CONSTRUCTION PLAN FOR:

CONTRACT NUMBER 82-073-05

REHOBOTH AVENUE BRIDGE NO. 153

1-15-87 AS BUILT PLANS P.K. E.I.

CONSTRUCTION PLAN - GROVE ST. REHOBOTH AVE. EXT. COLUMBIA AVE.

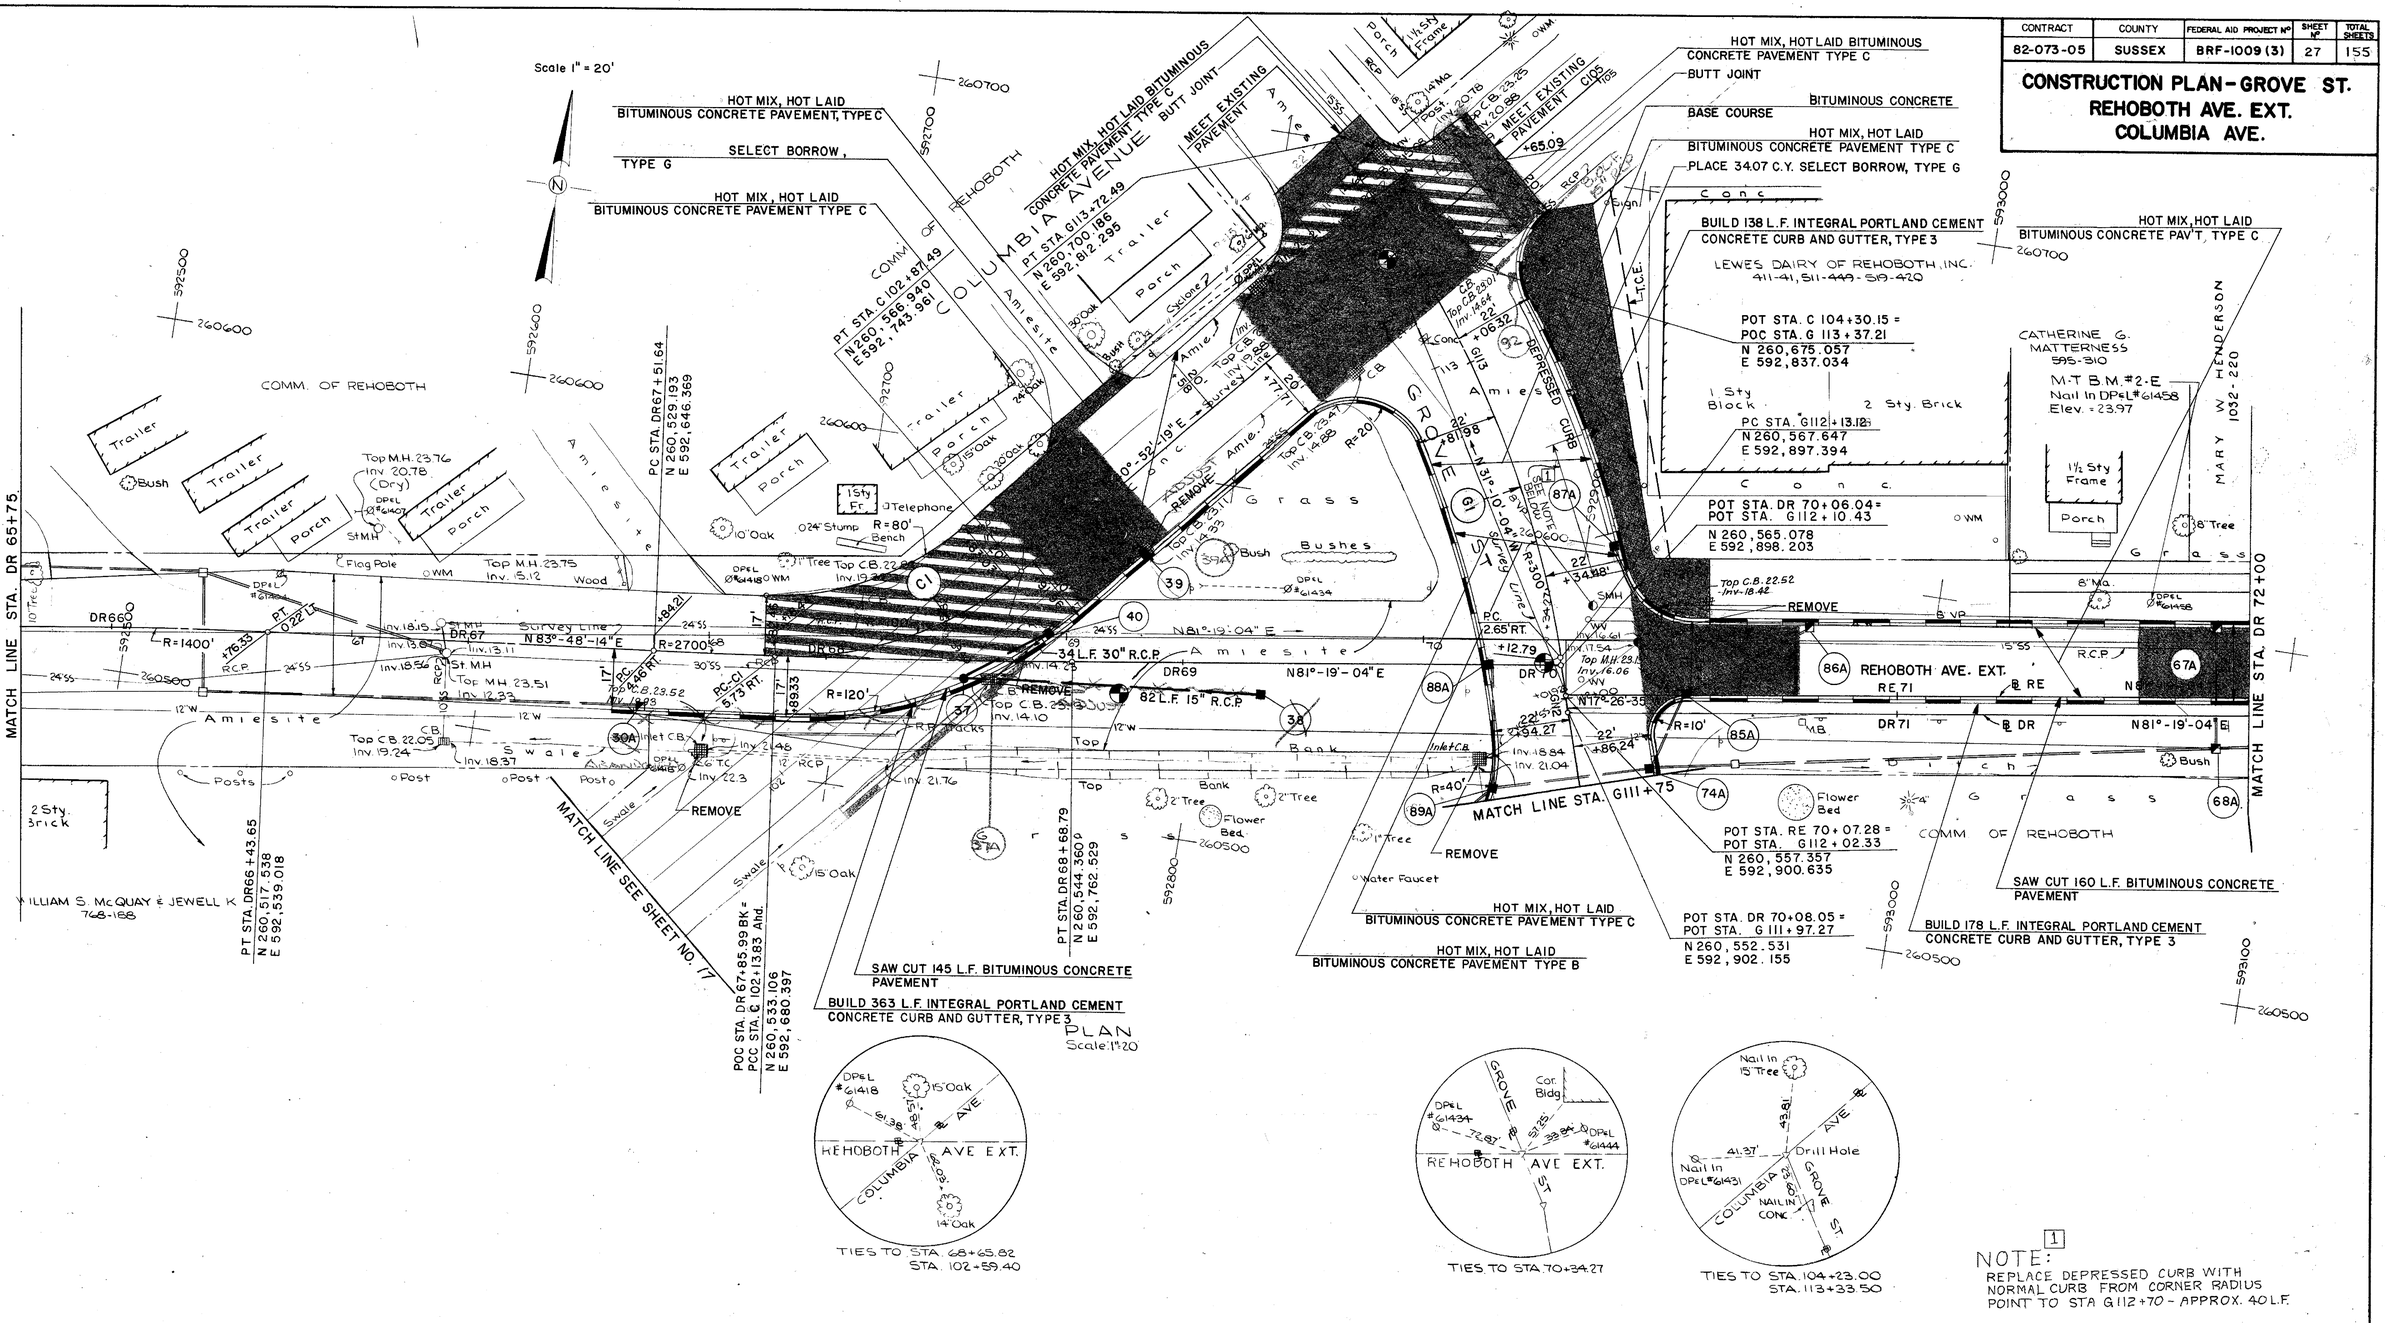
NOTE: [1]
REPLACE DEPRESSED CURB WITH NORMAL CURB FROM CORNER RADIUS POINT TO STA G112+70 - APPROX. 40 L.F.

CONSTRUCTION PLAN—REHOBOTH AVE.
STA. EB 37+85 TO STA. EB 40+50

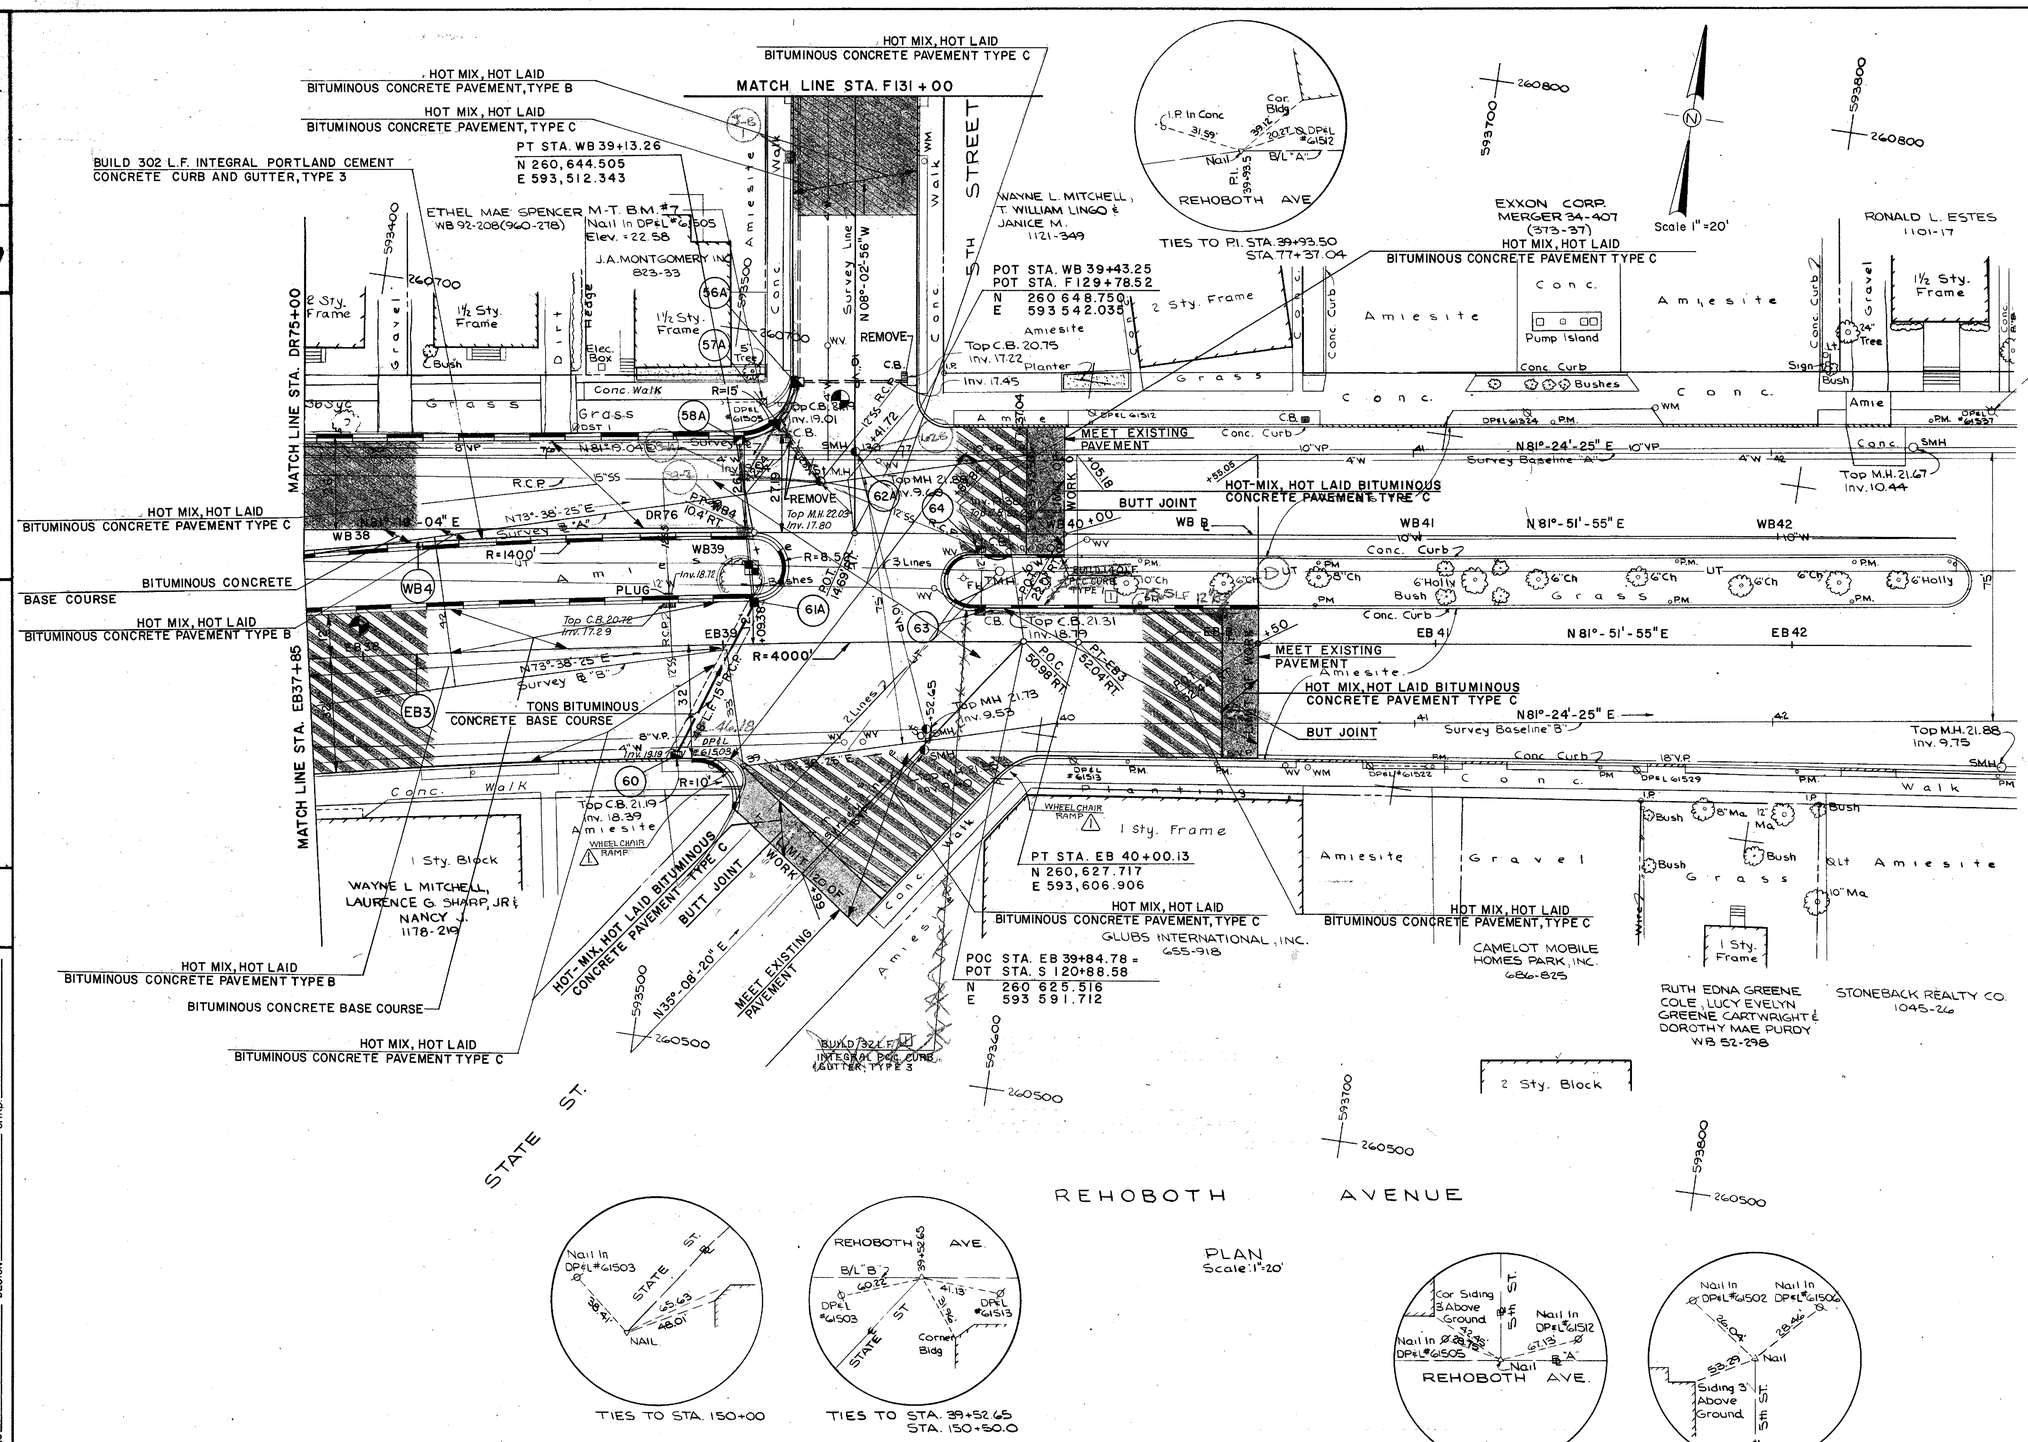
REVISIONS
1 ADDENDUM #2 - ADDED WHEELCHAIR RAMPS JHSJr. 9/24/84
2 ADDED CURB & GUTTER JHSJr. 3/24/86
